SERVICE INFORMATION LETTER

Subject: Installation Recommendations for Wencor Tubular Rivet PN 800162WE, installed in the JT8D Engine 7th Stage High Pressure Compressor (HPC) Disk.

Figure 3, Showing Undesirable Gap Under Rivet Head

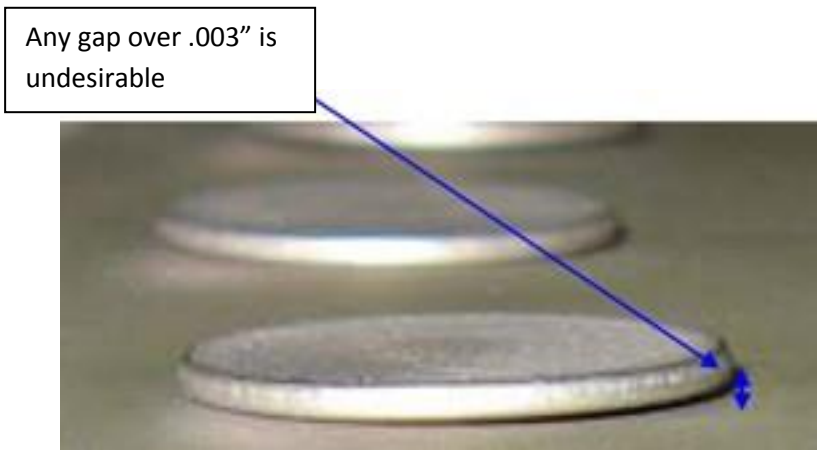
As shown below in Figure 3, examination of some rivets still installed in the disk showed that the rivet heads were not setting flat or parallel against the blade pin or disk surface after installation. This results in a gap between the underside of the rivet head and top side of the blade pin. Wencor considers any gap that is larger than .003" a contributing factor that could cause stress in the rivet radius that could contribute to head liberation.

The gap shown in Figure 3, results in uneven contact between the underside of the rivet head and the blade pin. The uneven contact is shown by witness marks on the underside of the rivet head as shown below in Figure 4. The uneven contact creates an undesirable bending stress at the rivet radius which could contribute to head liberation.

After the rivet flaring process, during step 2 of task 72-36-02-44-003-002 (JT8D-1/17 EMM for PN 481672) or in task 72-36-02-44-003-003 (JT8D-209/219 for PN 773128), verify that the gap between the rivet head and the blade pin as shown in Figure 8 does not exceed .003”.

Figure 5, Witness Marks Showing Incomplete Rivet Head Support

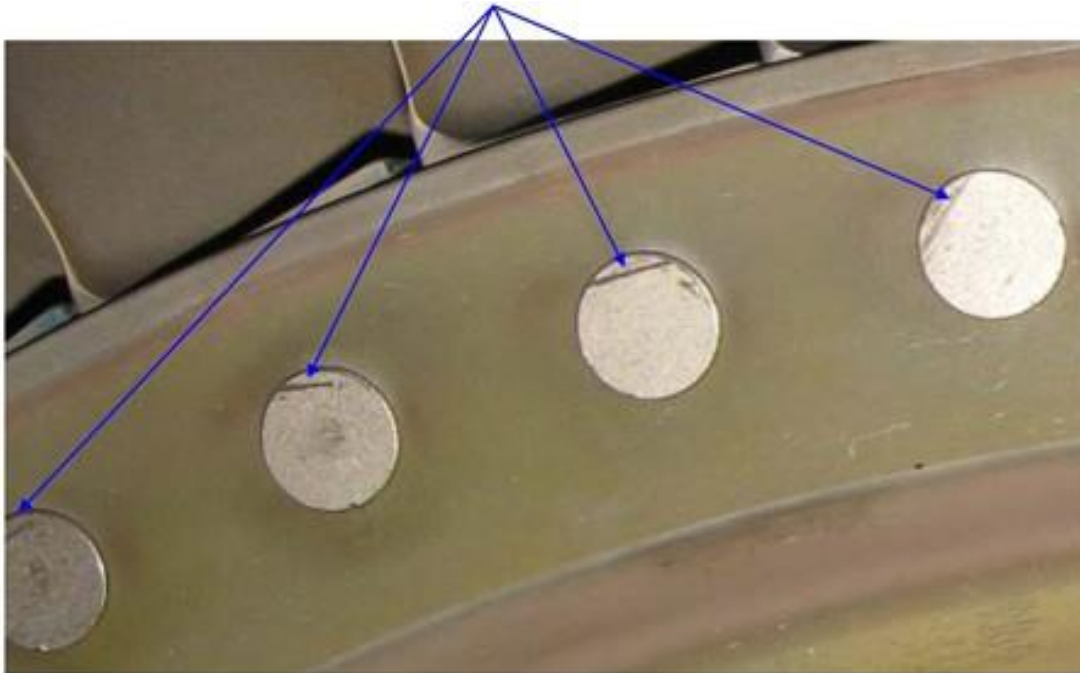
During the rivet flaring process, the rivet head is supported by a tool that incorporates a mandrel that should support the entire rivet head while the rivet is flared (see Figure 6 & 7). As shown below in Figure 5, examination of some of the rivets still installed in the disk showed evidence of incomplete support of the rivet head during the flaring process. If the entire rivet head is not supported during the flaring process, a bending stress would be generated at the rivet radius which could contribute to head liberation.

During the rivet flaring process, when the rivet is installed into the 7th stage disk and the disk is set upon the disk support tool (PWA 33565) as shown below in Figure 6 and described in step 1 of task 72-36-02-44-003-002 (JT8D-1/17 EMM for PN 481672) or in task 72-36-02-44-003-003 (JT8D-209/219 for PN 773128). Prior to flaring the rivet, the rivet head must be fully supported by the mandrel as shown in Figures 7 & 7a.

Figure 7a, Showing Simulated Rivet Head Position

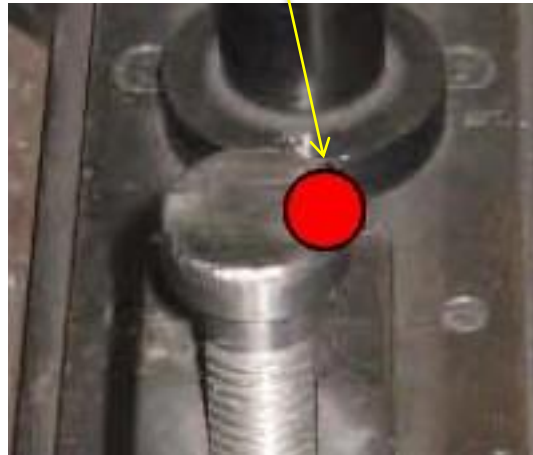
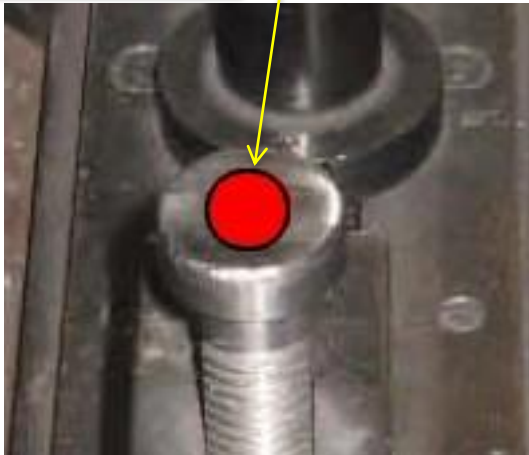
Simulated Rivet Head
Correct Position, Fully
Supported By Mandrel

Simulated Rivet Head
Incorrect Position, Only Partly
Supported by Mandrel
